**AGENDA REPORT
PLANNING AND ZONING COMMISSION MEETING
June 6, 2013**

A request by Collegiate Housing Partners, LLC to rezone approximately 1.25 acres from R-3 (Medium Density Multiple Family Dwelling) to PUD-90 (Planned Residential Development maximum 90 units per acre), to approve a PUD Development Plan to be known as "The Residences at 5th and Conley", and to grant variances to maximum building height, minimum perimeter setbacks, minimum landscaping/open space, required parking, and required public right-of-way width on adjoining public streets. The subject site is located on the northern half of the block bounded by Conley Avenue, 5th Street, Turner Avenue, and 4th Street. (Case#13-79)

Case 13-79: PUD Development Plan Collegiate Housing Partners, LLC

CONCEPTUAL LANDSCAPING PLAN

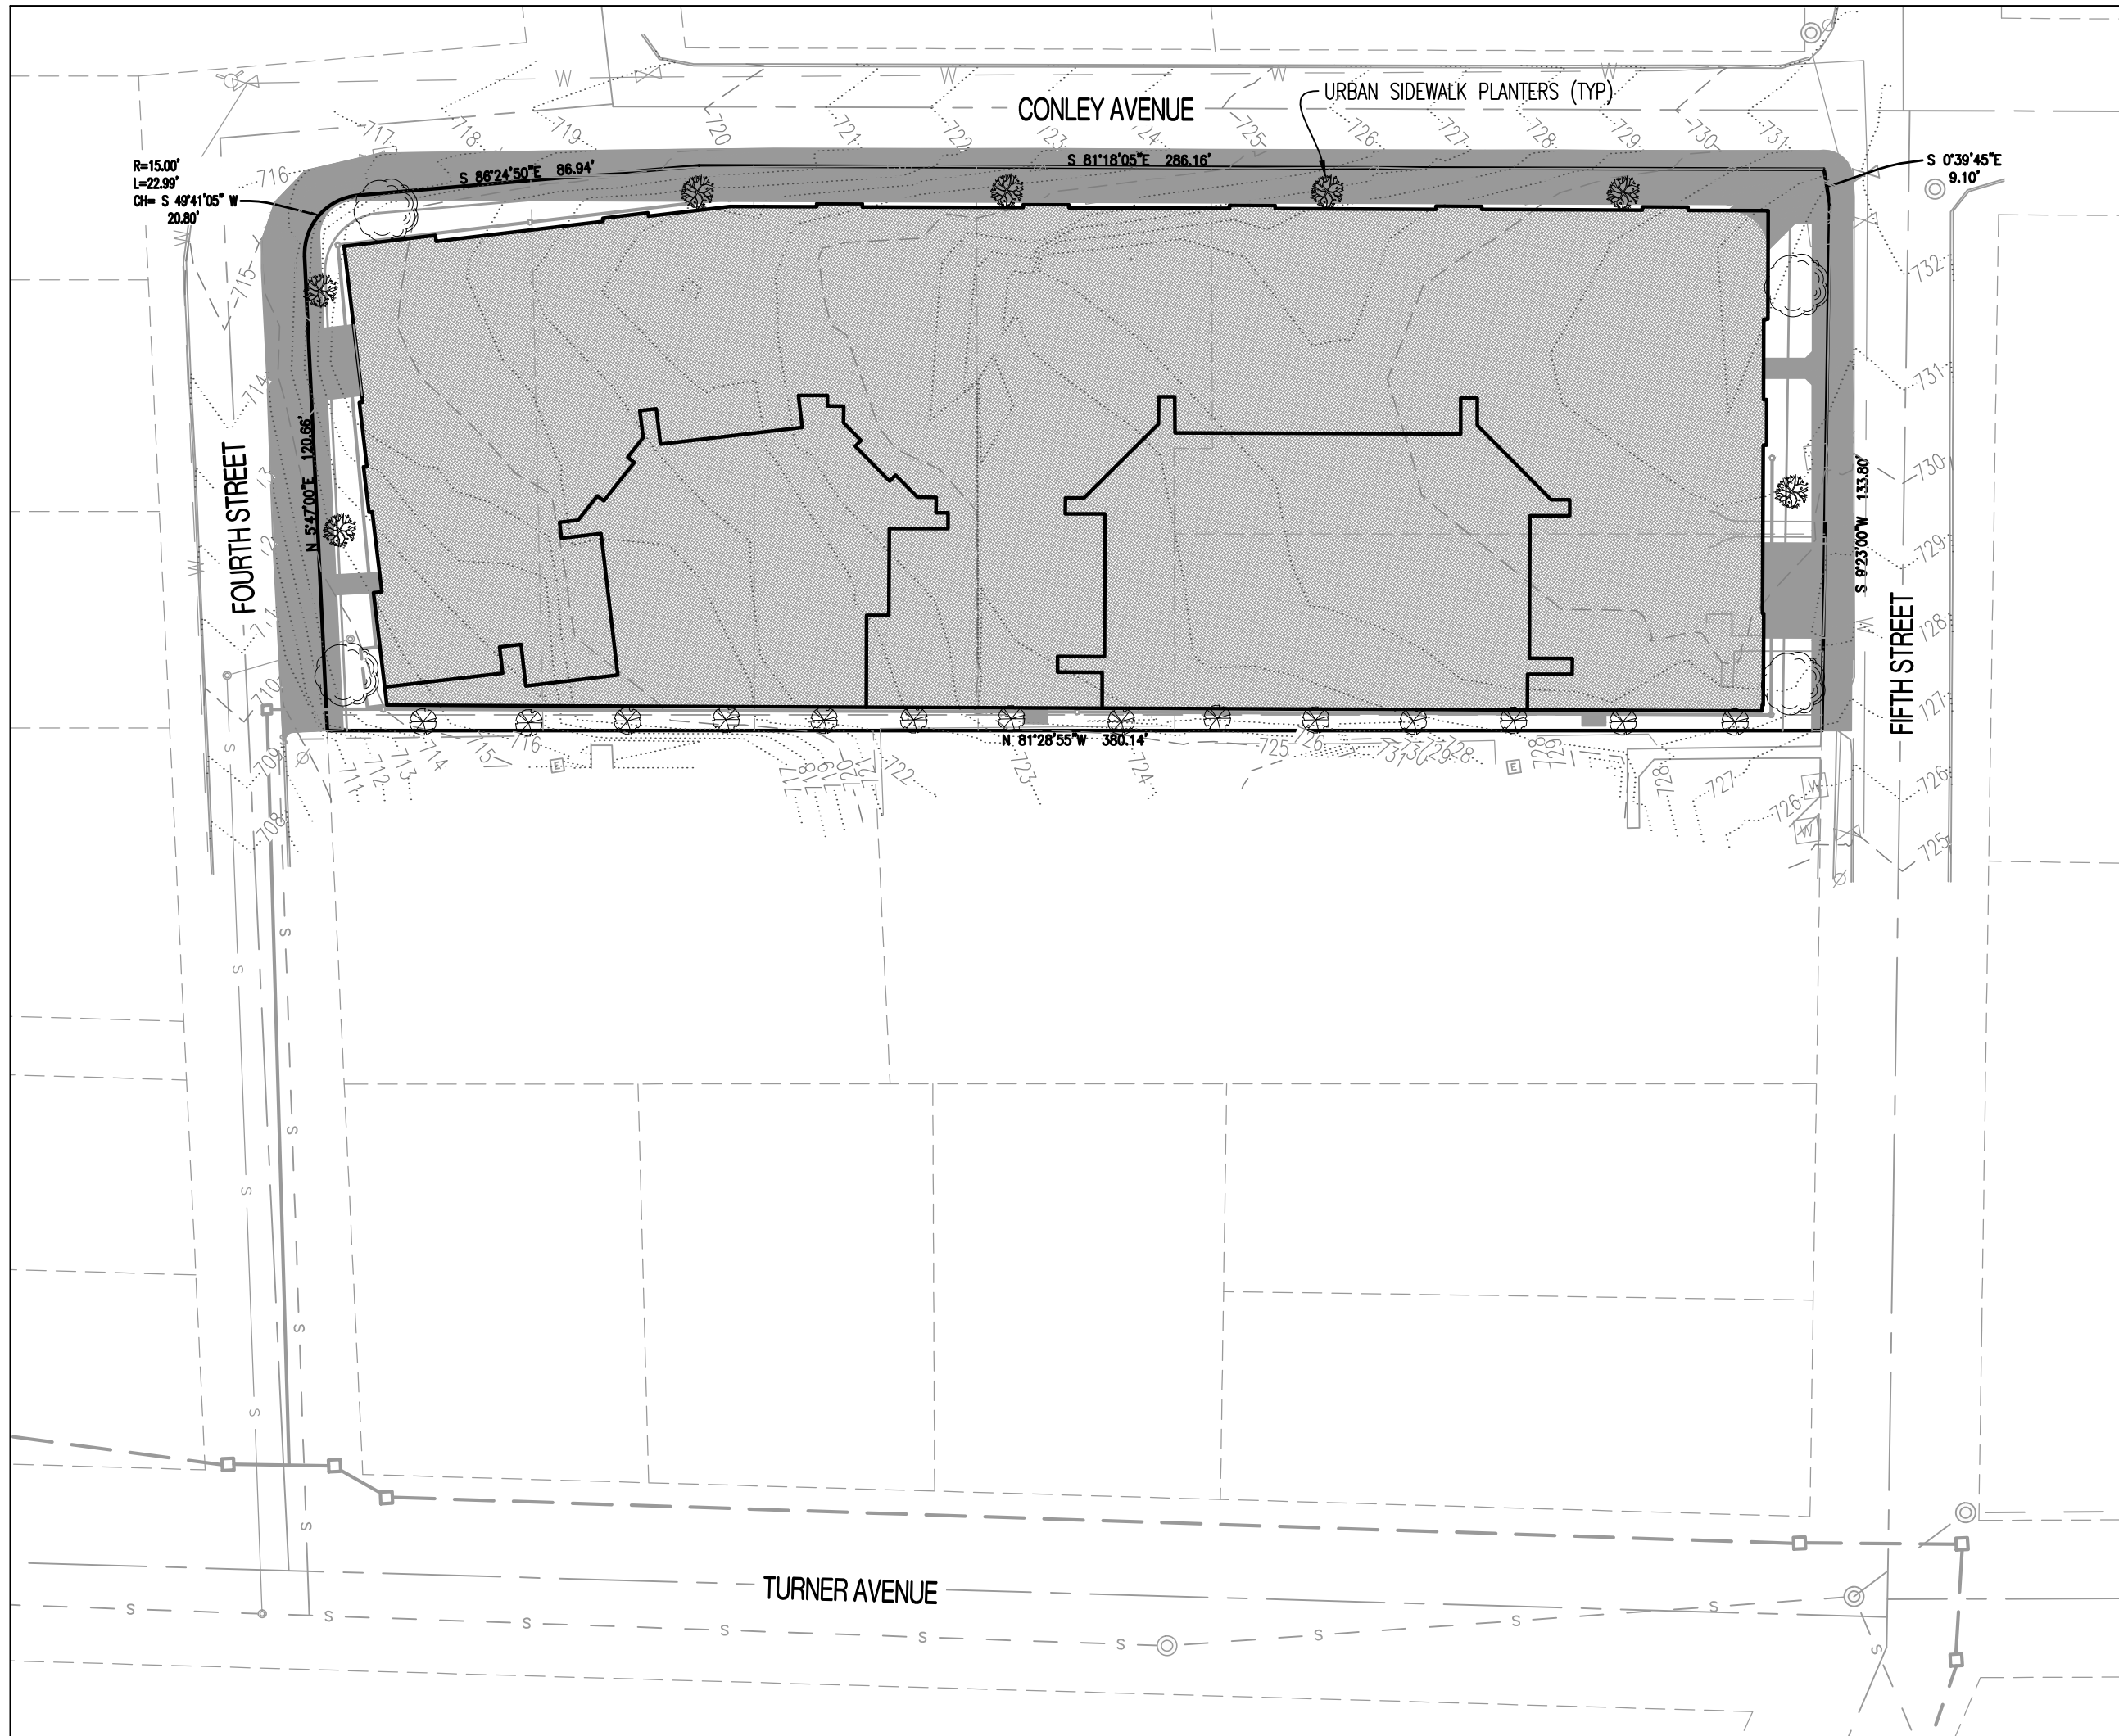
Concern exists; however, that the existing tree canopy along the southern property line will be eliminated further increasing the impact on adjacent residential uses. Furthermore, the setback proposed along this property line is questionable in its width to permit the replacement landscaping. Landscaping along this property line should consist of materials that, upon planting, will assist in reducing the visual disparities between the existing and proposed development and will, within four growing seasons, provide substantially similar screening that exists today.

8. Please see comment above.
9. Additional information has been added with this submittal as well as in the SOI to address this comment.
10. Additional landscaping materials have been added along the south side of the development to help with transition.
